Access Compliance Report

Public Rights-of-Way

Intersection ID: 29917	Main Street: BEMBRIDGE_CT	Cross Street: NORTHRIDGE_DR	Location: SE
ADA ID: 7F58FCF77A34	Ramp Type: BlendTrans1	Initial Pass/Fail: Pass	Overall Compliance: No
Severity Score: 5			
Codes/Mitigation Info/Possible Solution		Field Measurements/Component Compliance

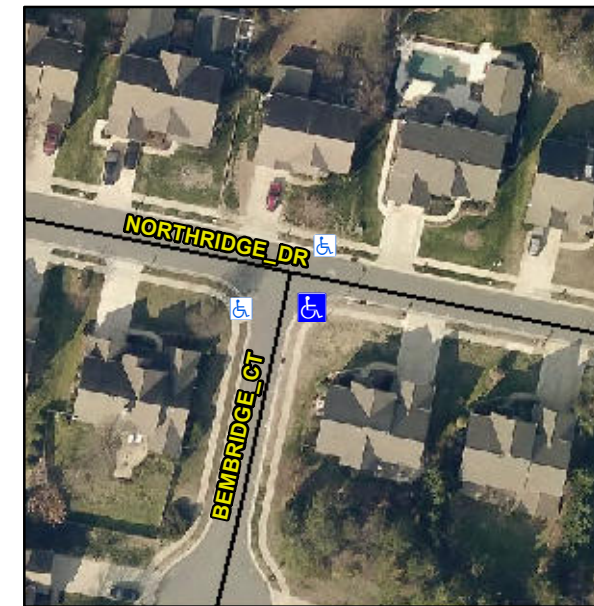
Not Found, R304.2.1, R304.5.4, R304.5.3

N/A	Ramp inside XWalk1?	N/A	N/A	Ramp inside XWalk2?	N/A
	Road Slope (%)	2.7		Clear Space?	Yes
	Road X Slope (%)	0.3	N/A	Clear Space to XWalk (in)	N/A
Yes	Any Obstructions?	No	Yes	Storm Grate/Utility Hazard?	No
	Obstruction Type			Storm Grate/Utility Type	
		N/A			N/A
			Yes	Surface Condition? (G/P)	Good
			No	Curb Slope (%)	7.0

Remove & Replace Curb Ramp With Two New Directional Ramps or Equivalent. Remove & Replace Gutter.
